Enhanced LIGO TCS Review

Aidan Brooks, Tobin Fricke, Virginio
Sannibale, Peter Veitch, Phil Willems

January 10, 2008

Reviewers' Laser Comments

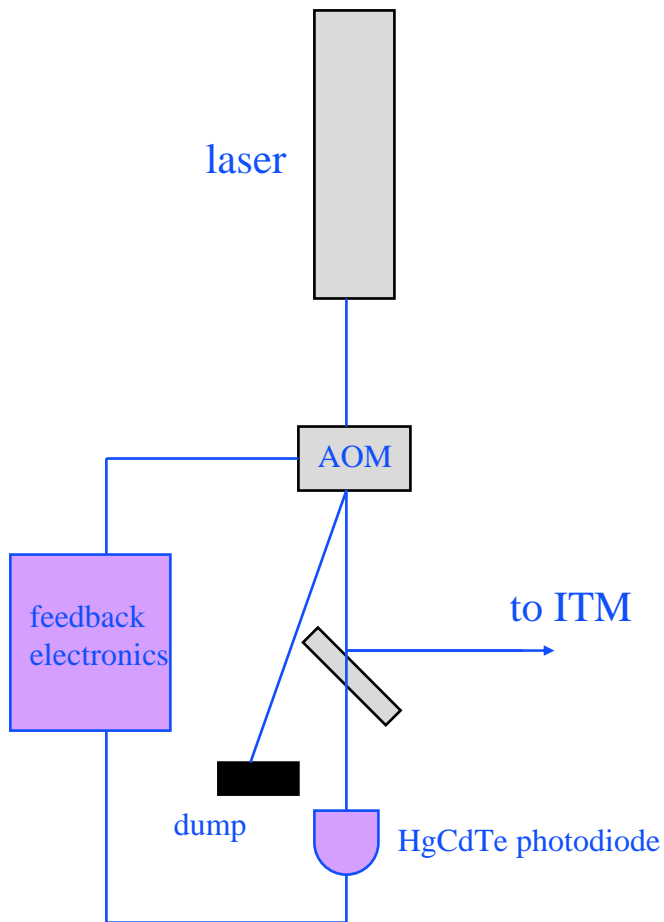
- “If the laser is CW, does it make sense to operate it at a power level close to the operating point, so the polarizer may induce less power dependent deviation?”
 - » Yes. The laser operates CW only at full power, but the AOM can divert a large, unneeded fraction to a beam dump, sparing the downbeam optics. The pickoff mirror transmissivity to the ISS PD should then be chosen for optimal through power at this incident level.
- “Are the currently installed polarizers able to withstand higher powers?”
 - » The PHB-7 polarizer by OFR can handle 1 kW CW.
- “The old polarizer/beam dumps should go away- update to the LHO high power TCS design or similar: polarizer secured by a clamp, beam dump separate from rotator.”
 - » Will do.

Reviewers' Comments

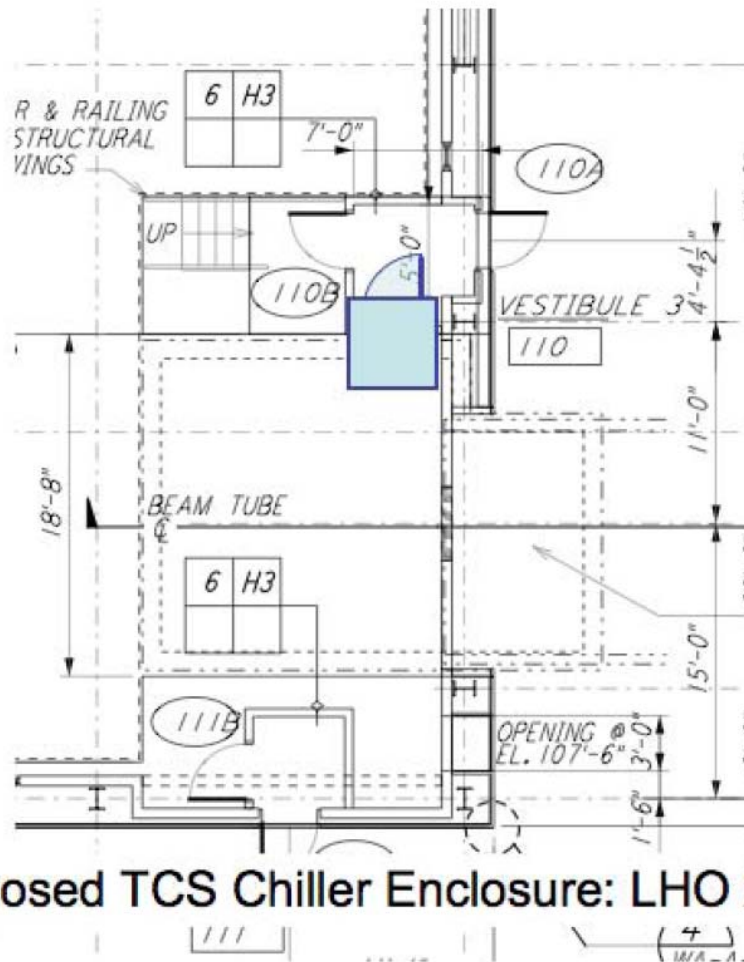
- “Don’t you need to scale the servo mixing dynamically? The heating for X and Y certainly changes dynamically.”
 - » Yes, the servo mixing would rescale with power. Heating might be fixed in detection mode, so scaling may not need to adjust on the fly.
- “How good does the matching between paths have to be for this to work? Since it increases the individual lasers’ noises it seems like there would have to be a common mode cancellation which is as good as the servo action. 1%, 10%?”
 - » If noise is truly correlated from TCS tables, then any CMRR will help. For example, if one TCS table were utterly quiet, adding the noise of the other would help even if noise coupling were 50% off between arms. The question is how correlated the two tables can get.

Measured axicon intensity profiles

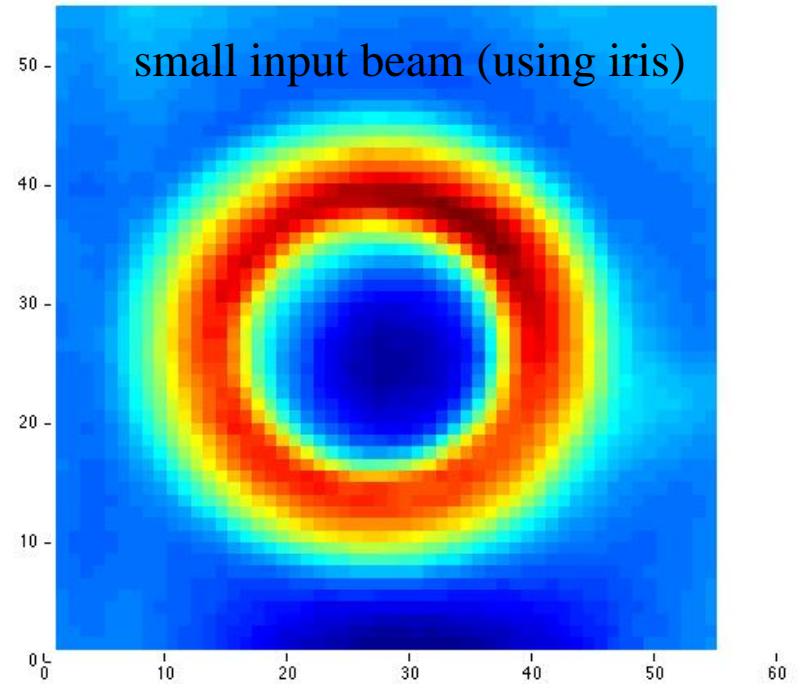
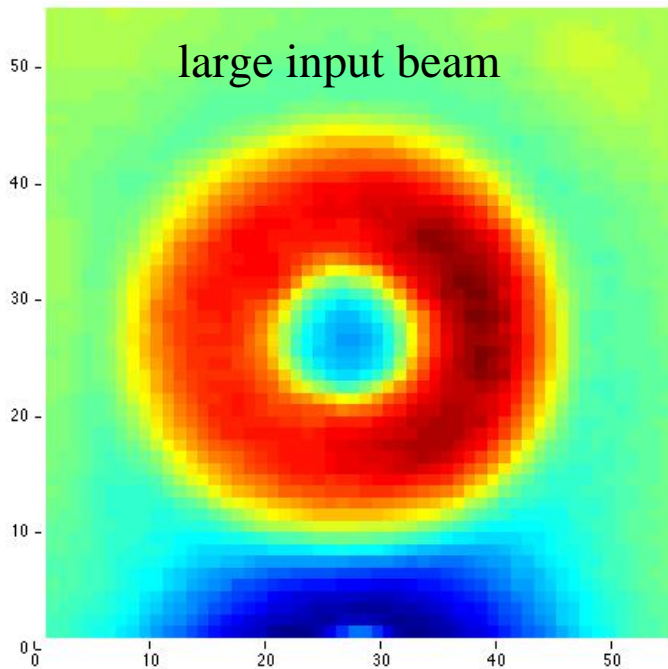
- “What are the requirements on the uniformity and the centering of the annulus heating pattern?”
 - » We have no solid requirements on uniformity. Centering requirements should be the same as in initial LIGO, within 10mm.

- “How hard is it going to be to change the size of the annulus pattern?”
 - » Not too hard. The axicon separation can be changed to vary the pattern without defocusing the projector. Plus, we can still tweak the output profile with masks.

- “Have there been any stability tests?”
 - » Not so far. Estimates of required stability of axicon mounting seem well within optomechanical capabilities. We may, however, want to move the rotating polarizer after the axicon.

- “Is the pattern projected by the axicon roughly the same as the old annular mask?”
 - » It is better. The old annular mask pattern is strongly peaked at the inner radius, while the axicon moves the power further out where we want it.

- “Is the back scattering from the axicon any smaller or larger than the old system?”
 - » The axicon itself should not contribute backscatter, if we point the conical surface toward the laser. The rest of the system should scatter about as before.

- “What would we gain by using the axicon instead of the annular mask?”
 - » Two things: a better spatial profile (see above), and much more efficient power delivery (89% compared to ~30% with the mask)
